June 13, 2014

RE: Municipal Solid Waste – Webb County
Pescadito Environmental Resource Center (MSW 2374)
Revisions to Parts I and II

MSW PERMIT NO. 2374

**PESCADITO ENVIRONMENTAL
RESOURCE CENTER**

FIGURE 1 - PART II GENERAL LOCATION MAP

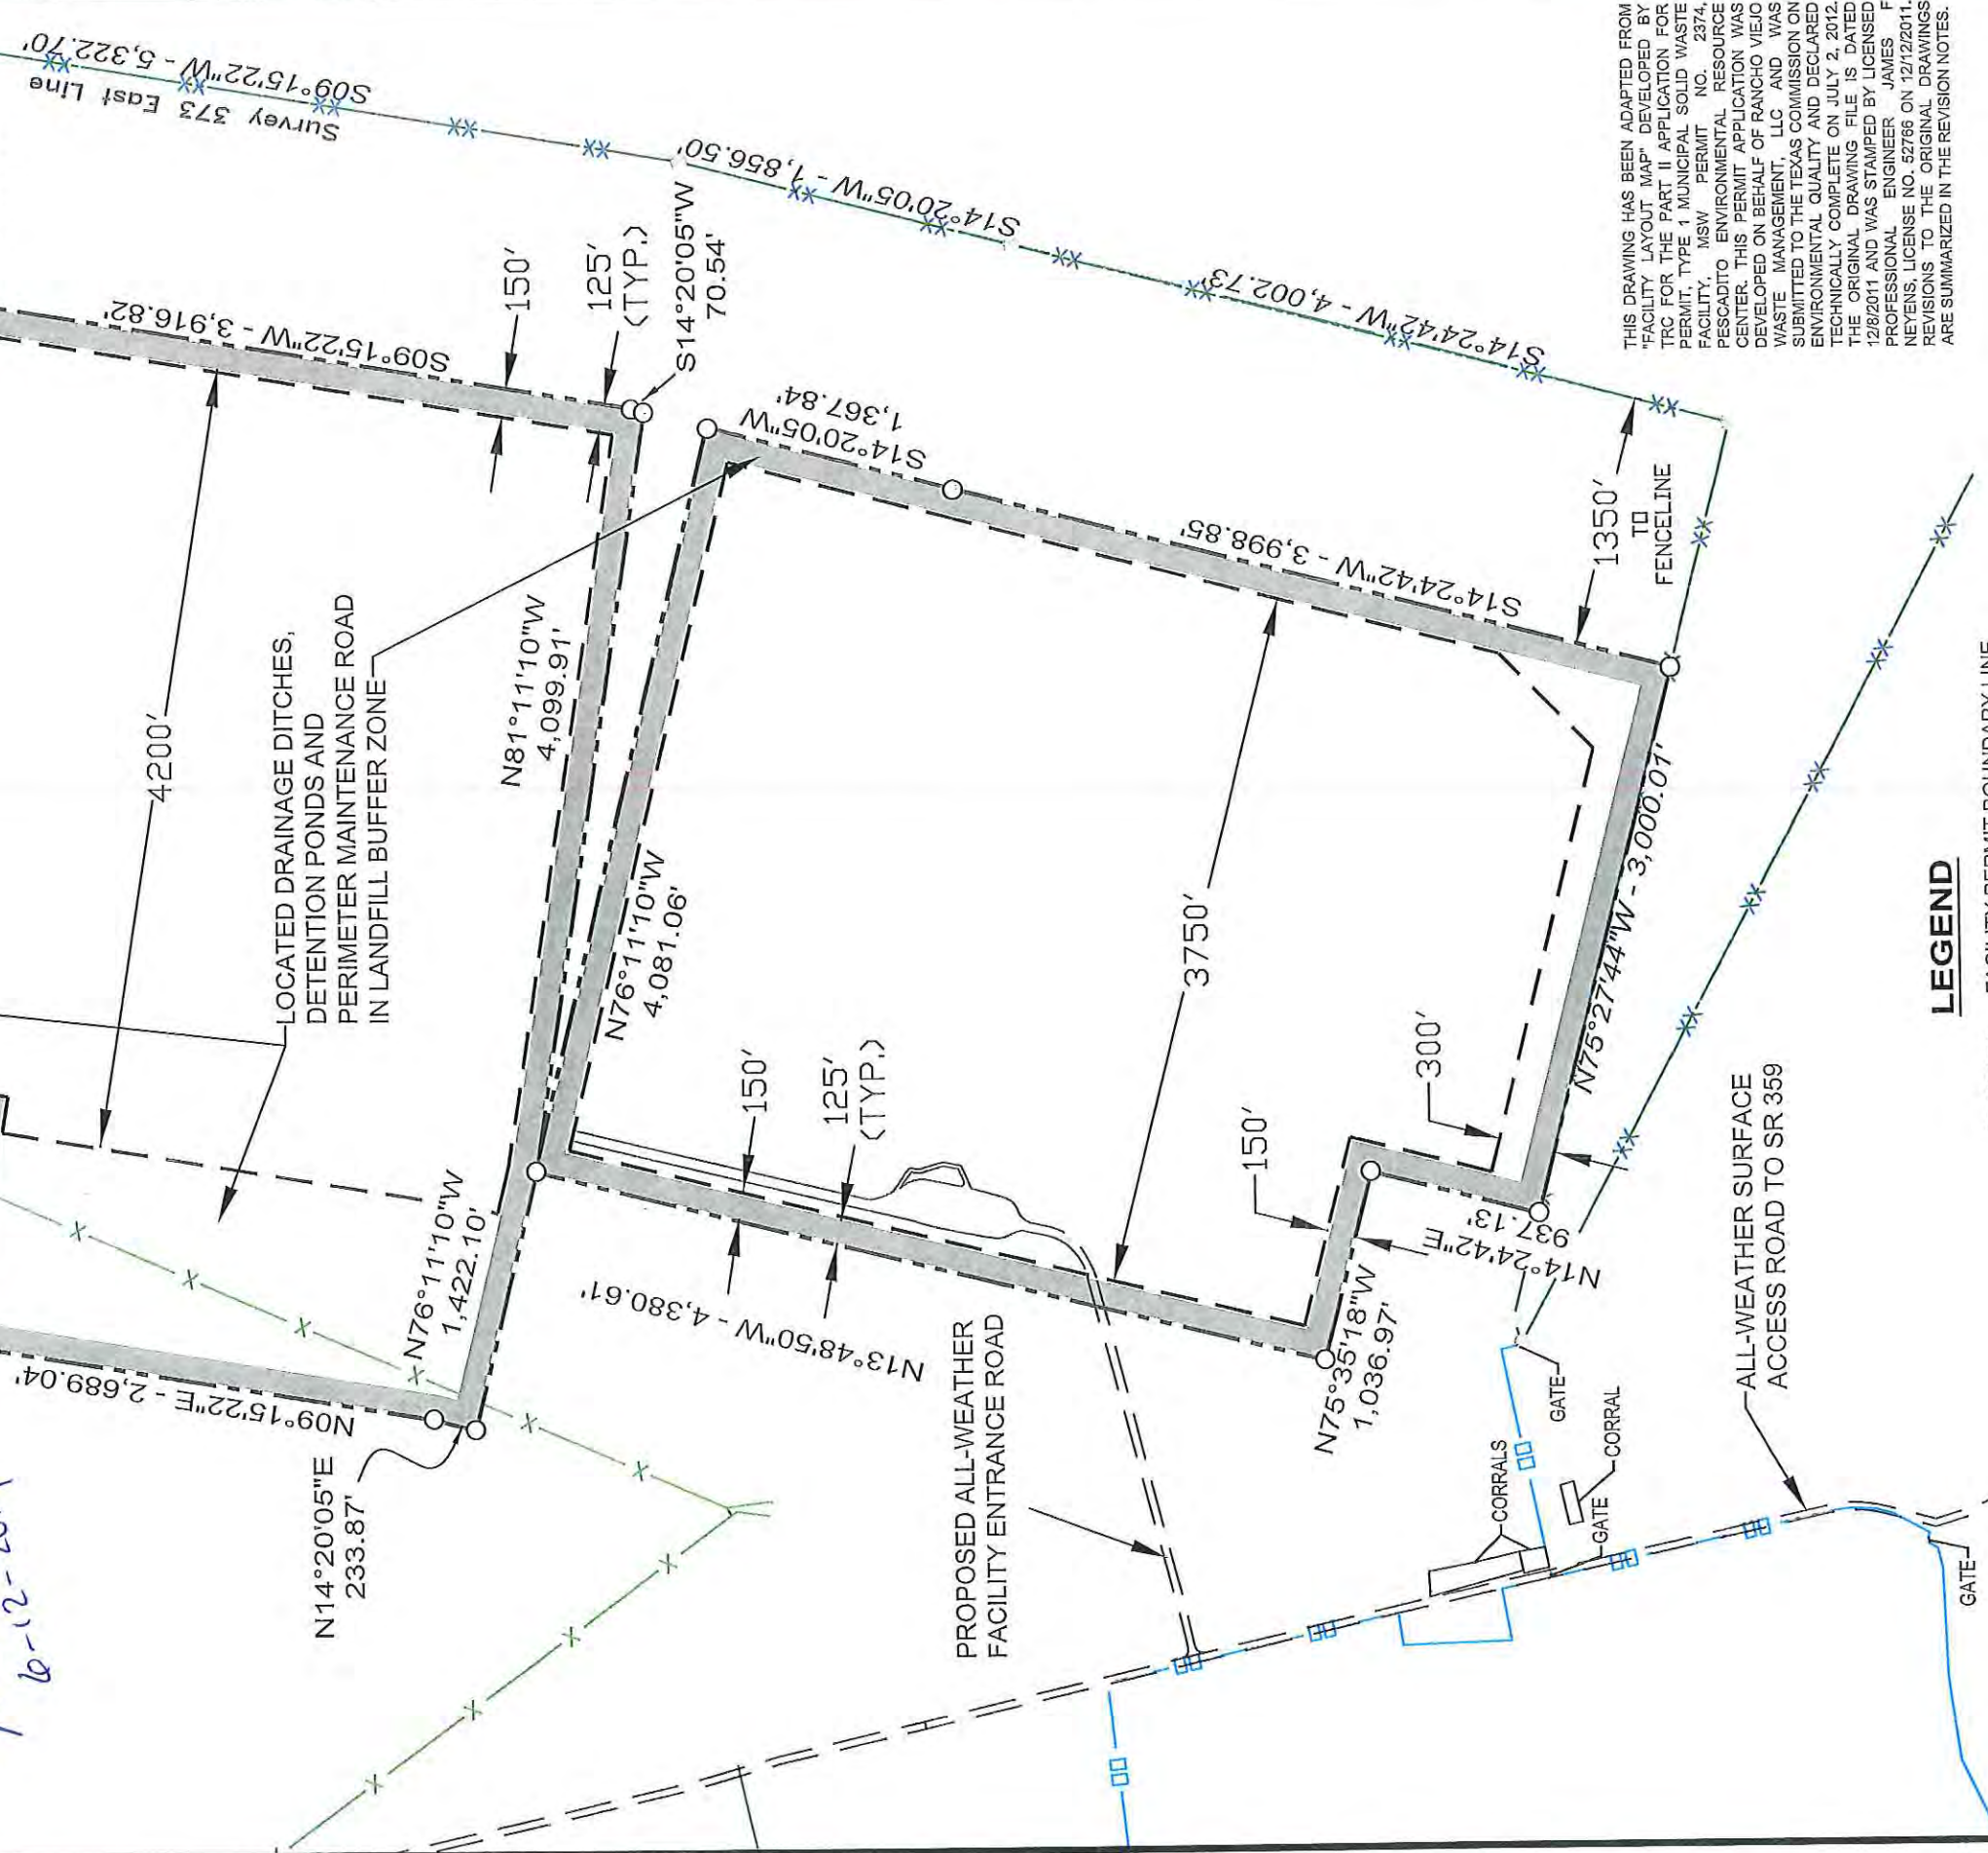
REV. 1 5/22/14 - REVISED FACILITY PERMIT
BOUNDARY

FIGURE 3 - PART II FACILITY LAYOUT MAP

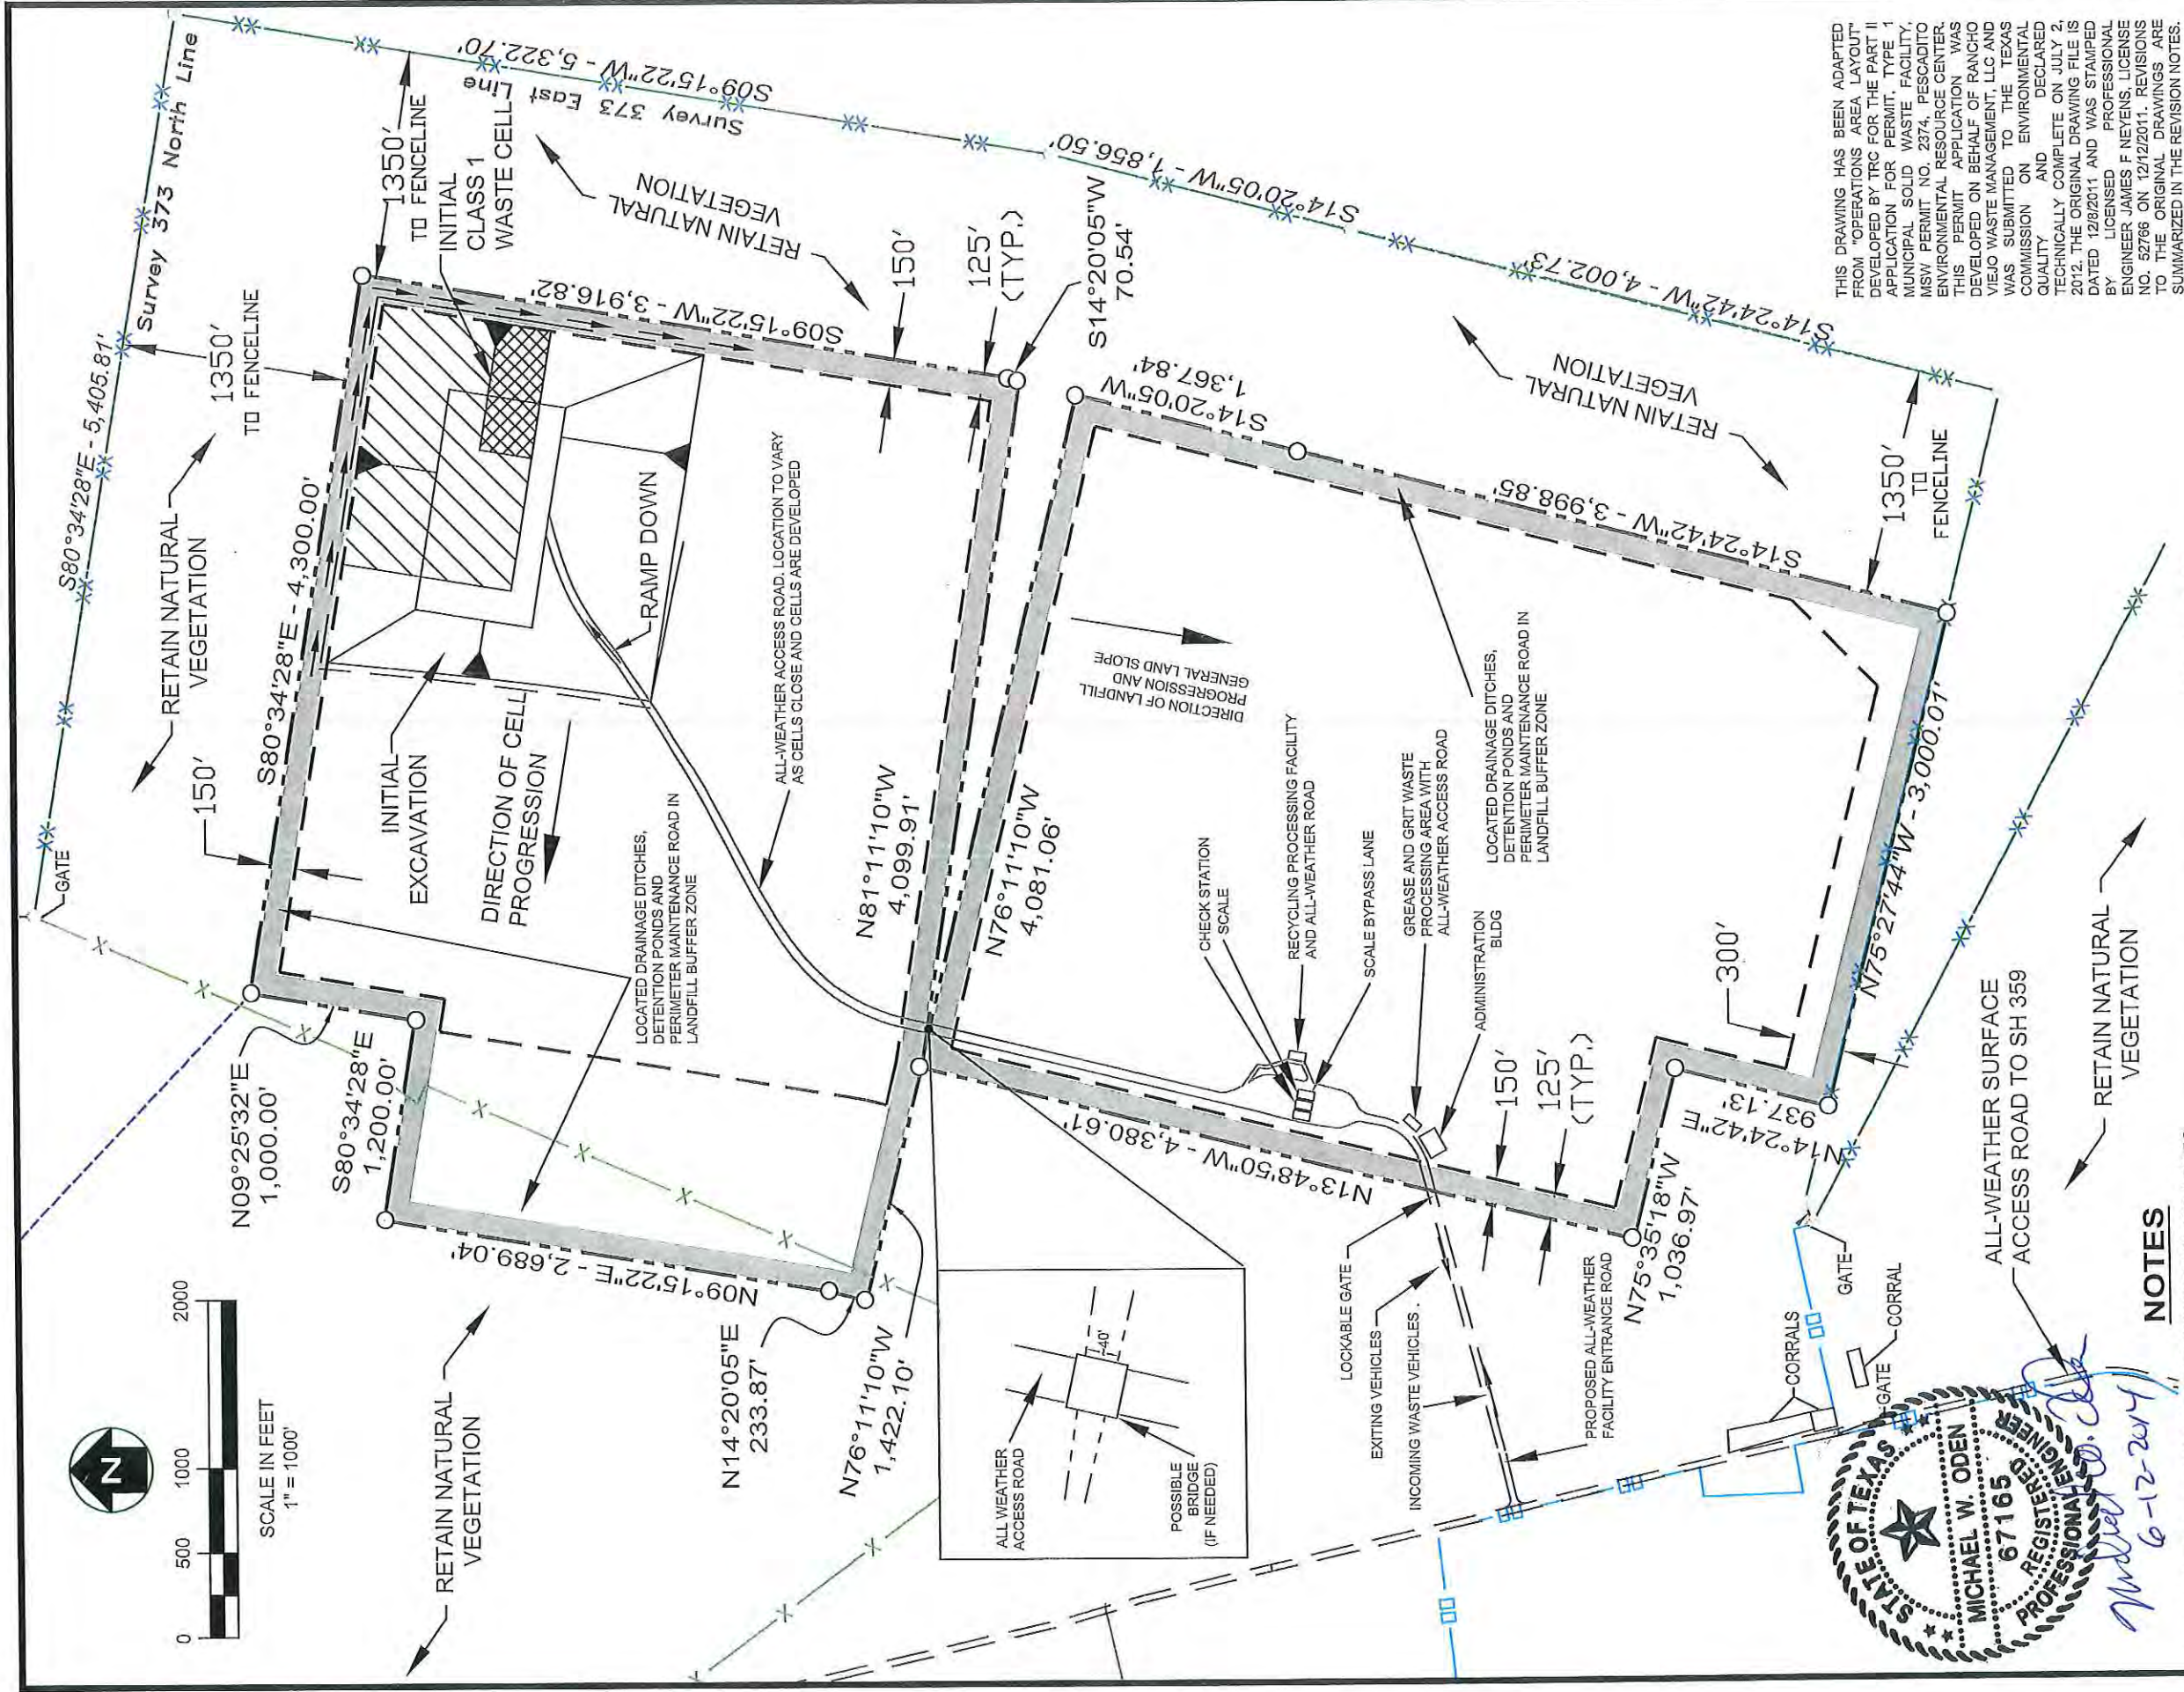
REV. 1.502/14 - REVISED FACILITY PERMIT BOUNDARY

FIGURE 4 - PART II
OPERATIONS AREA LAYOUT

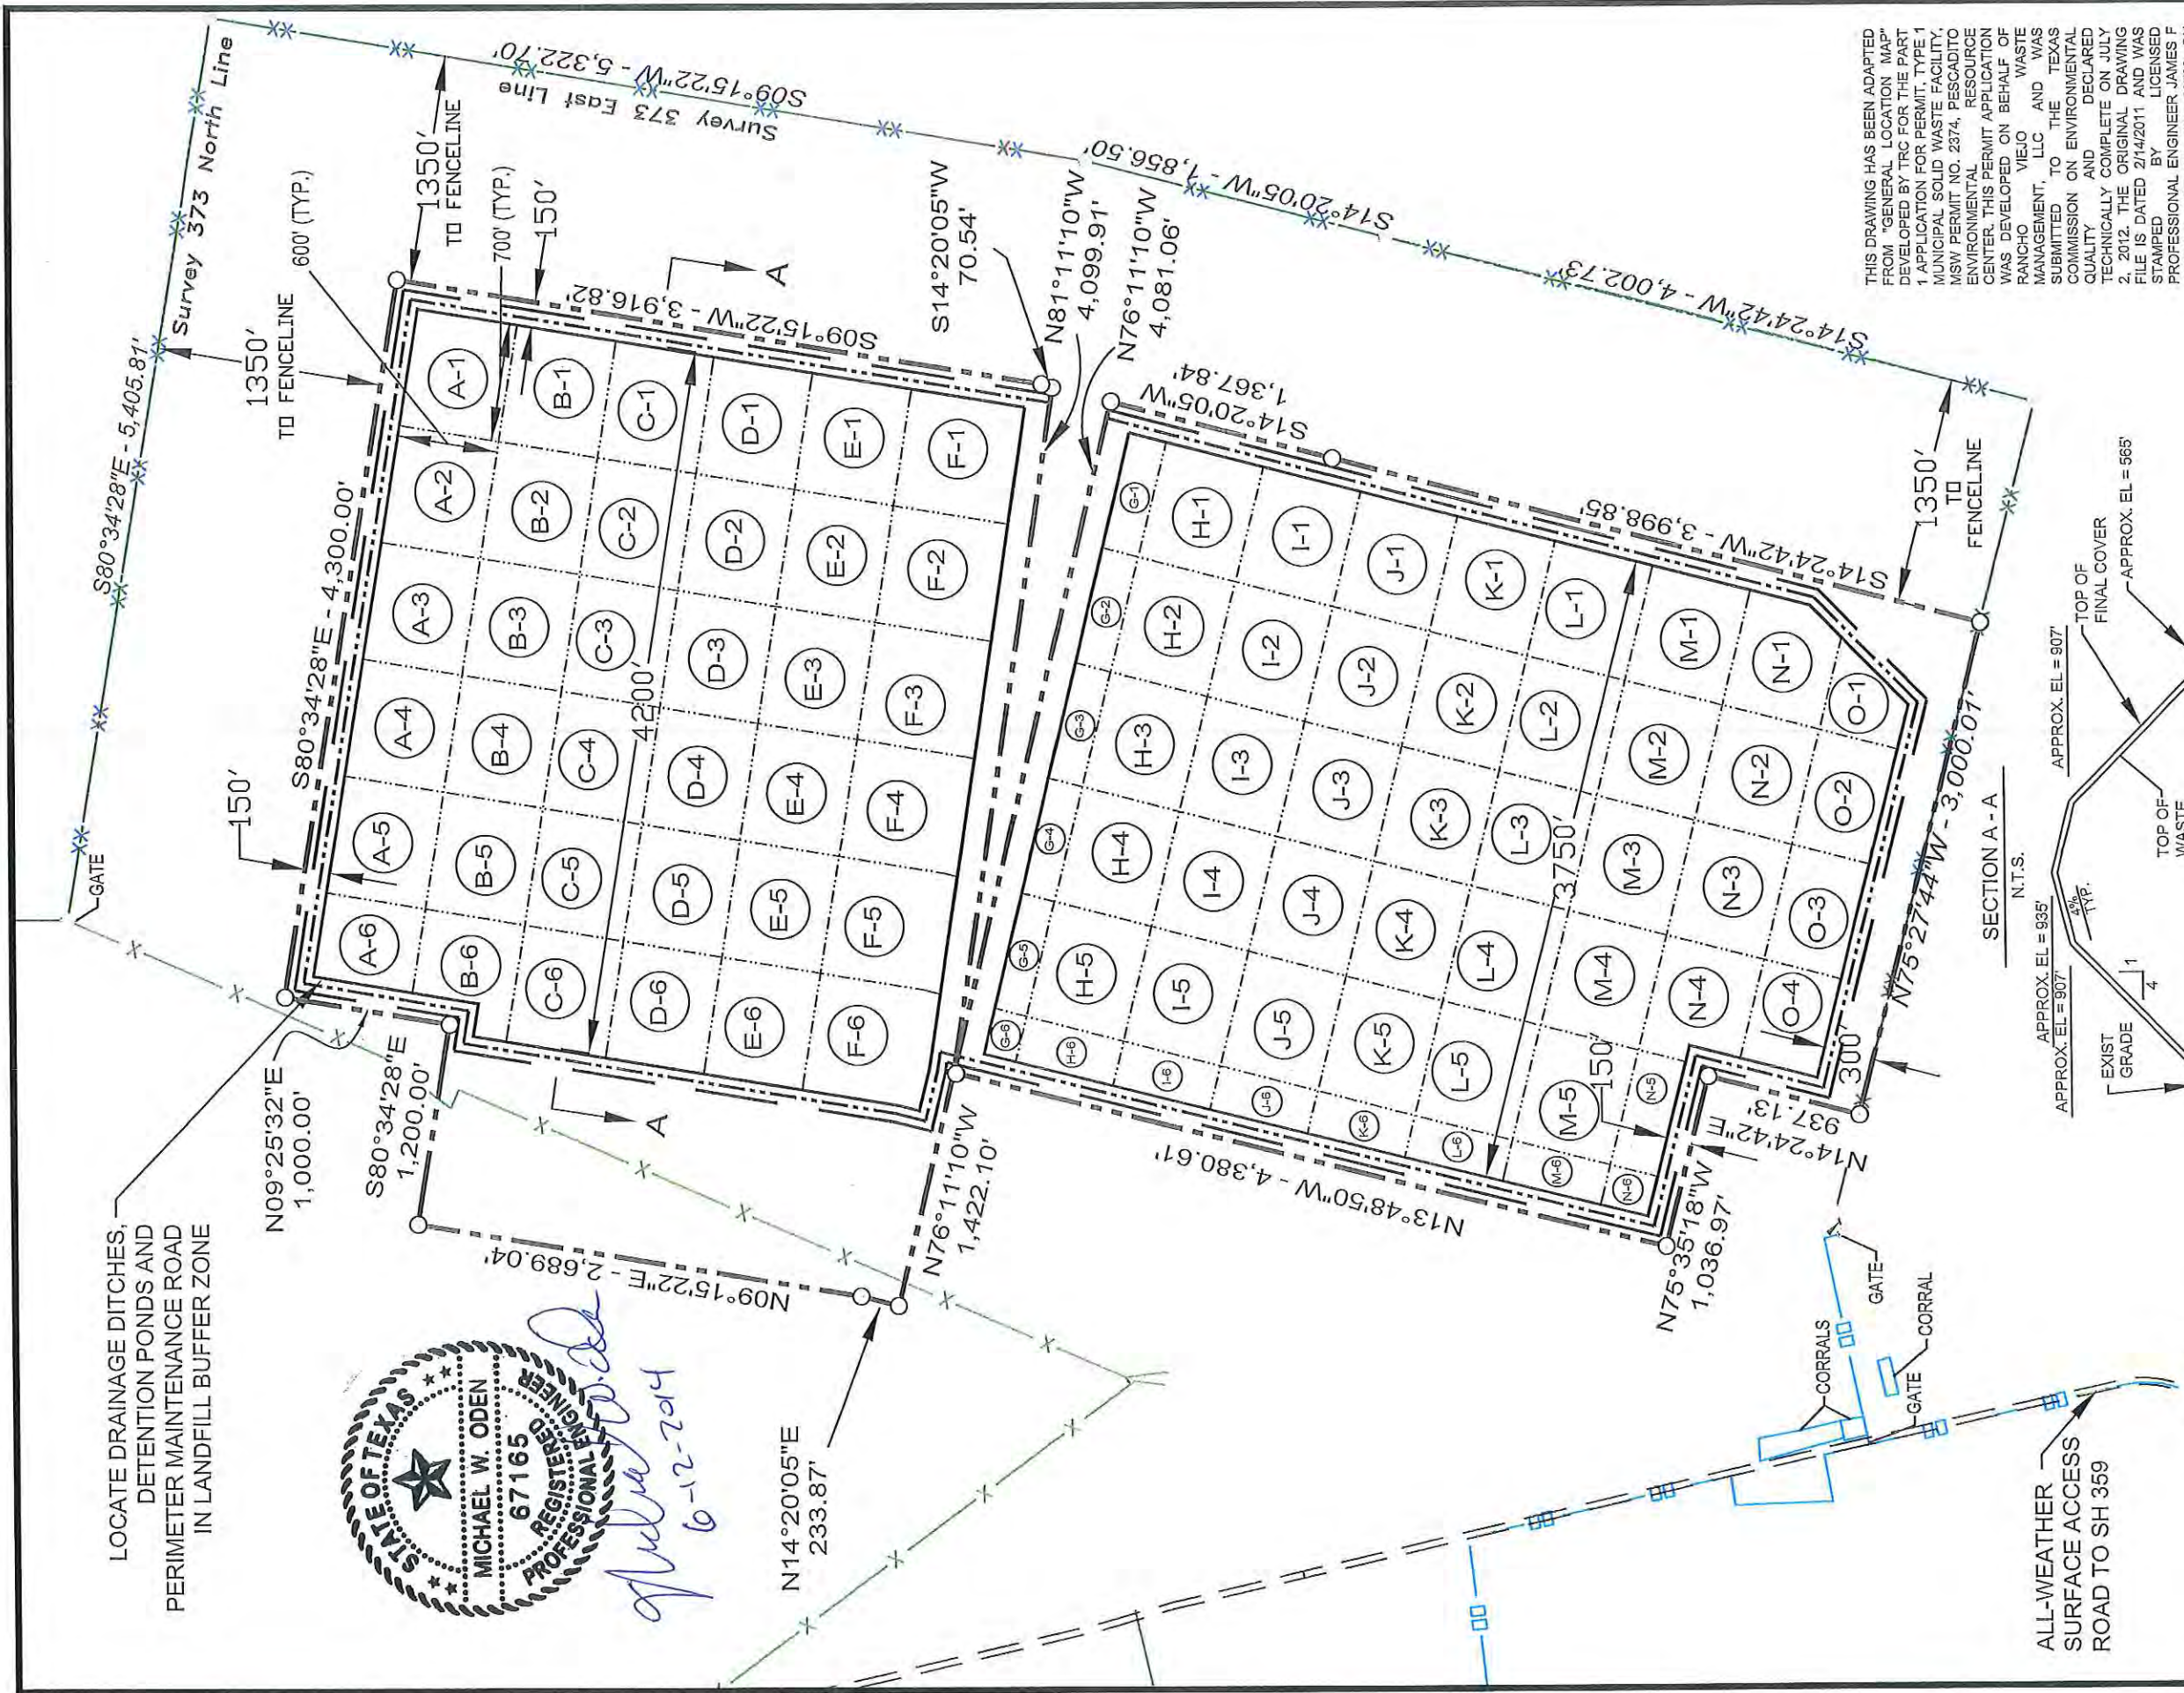
REV. 1.502214 - REVISED FACILITY PERMIT BOUNDARY
